**City of Ashland, Missouri
Special Meeting Agenda
Board of Aldermen
7:00 p.m. Monday, August 9, 2021
VIA ZOOM**

DATE: July 6th, 2021
TO: Board of Alderman
FROM: Dan VandeVoorde, Community Development
SUBJECT: Lakeside Development Gravel Parking/Access Driveway Variance Request

DATE: July 6th, 2021
TO: Planning & Zoning Commission
FROM: Dan VandeVoorde, Community Development
SUBJECT: Lakeside Development Video Screen Height Variance

SITE PLAN FOR LAKESIDE DEVELOPMENT

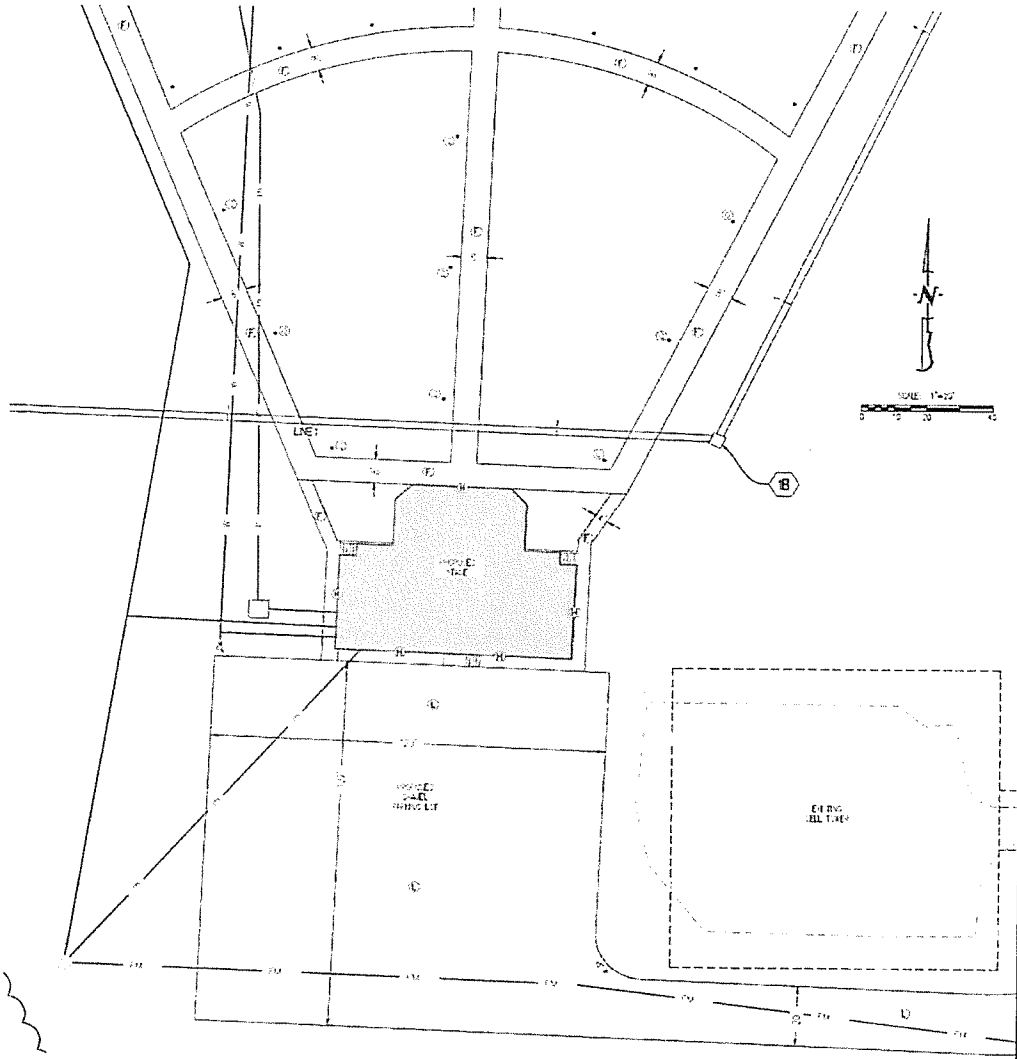
LOCATION OF PROPOSED GRAVEL PARKING AREA

With this site plan submittal, the engineer of record, Crocket Engineering Consultants, on behalf of Parks Properties, LLC has requested a variance for the requirement of paving the loading area behind the stage that also includes the access drive. The total area of gravel that includes both the parking area and drive is approximately 27,240 square feet.

The applicant has requested a variance from this requirement to allow the construction of a driveway and parking area made out of gravel. Typically, the intent of this ordinance is to have an aesthetically pleasing dust free area that is used to carry out the functions of the business. Another factor for the paving ordinance is to allow for the striping of the parking spaces that are required by ordinance.

After careful consideration of the requested variance submittal staff is in **support** of the variance request.

The proximity to neighboring business and residents would not be affected by dust created by the gravel surface. The area would not be used by the public and generally used for loading/unloading and facility vehicle uses, therefore there would not be a need for striping.

NORTH (front) ELEVATION

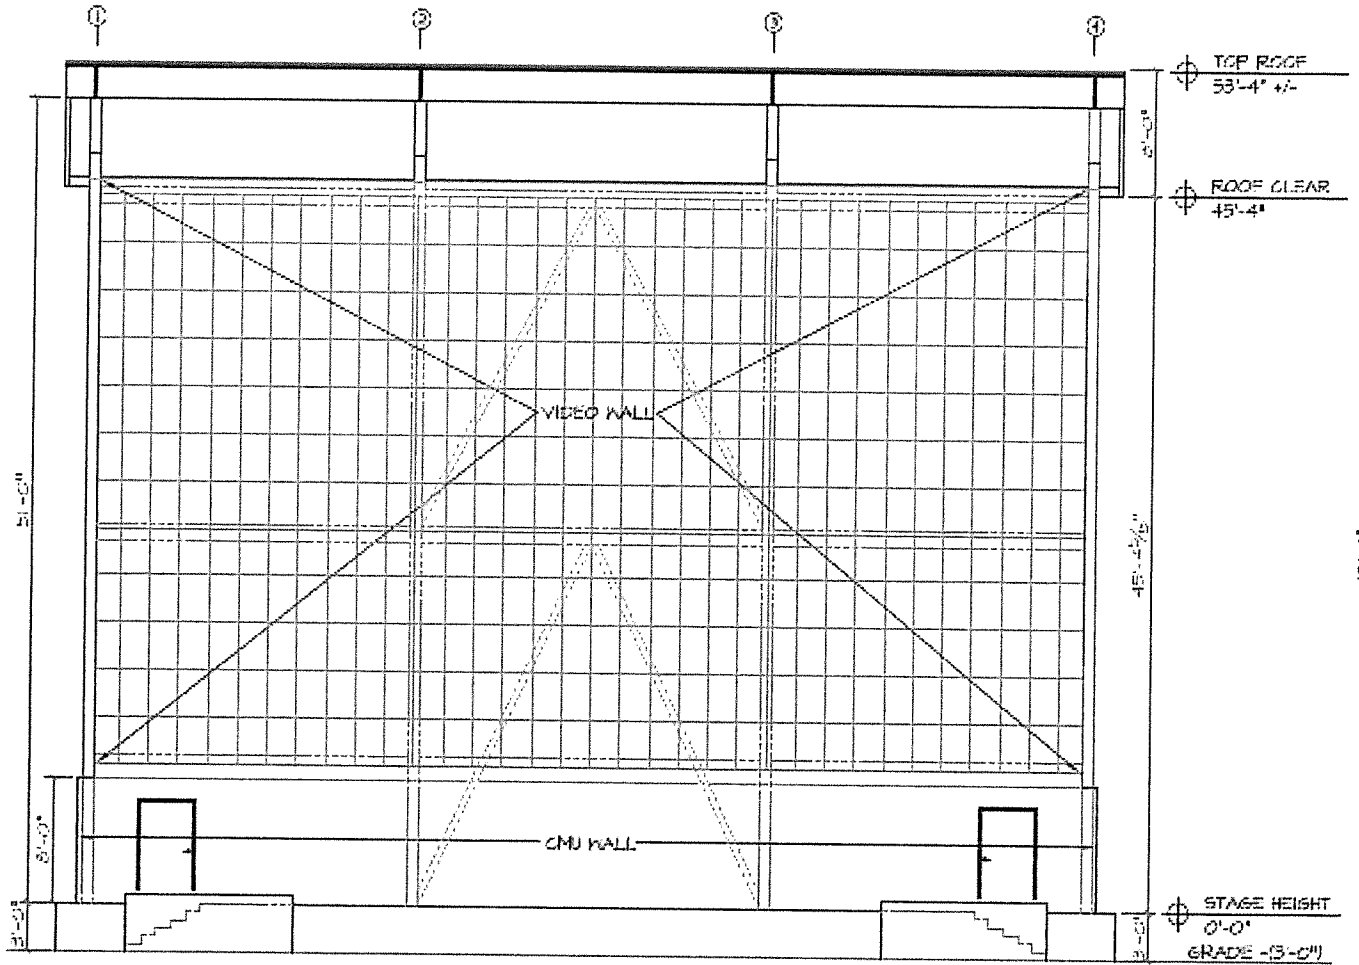
With this site plan submittal, the engineer of record, Crocket Engineering Consultants, on behalf of Parks Properties, LLC has requested a variance to exceed the maximum *Structure* height from **45' to 53'-4"** for a total amount of **8'-4"** over the maximum height allowed by City Code

The applicant has requested a variance from this requirement to allow the construction of an outdoor video screen with stage. This structure has a footprint of approx. 3,300 sq ft with a video screen dimension of approx. 70' wide and 38' in height.

After careful consideration of the requested variance submittal staff is **indifferent** in the support of the variance request.

While it is understood that this video screen is a major element of this development, City Staff does not have technical knowledge of video screens size and other technical aspects of what it takes to properly host an outdoor movie viewing business.

Building height restrictions are typically in place to limit sight lines, account for aesthetics, and restrict the density on a parcel. In this case, the use and type of this structure is not necessarily what normally would consider a building, but under the definitions it is. City staff does not feel that this structure is in opposition to the intent of the height ordinance. The parcel size appears to accommodate for increased height and any increase in density that it would cause.
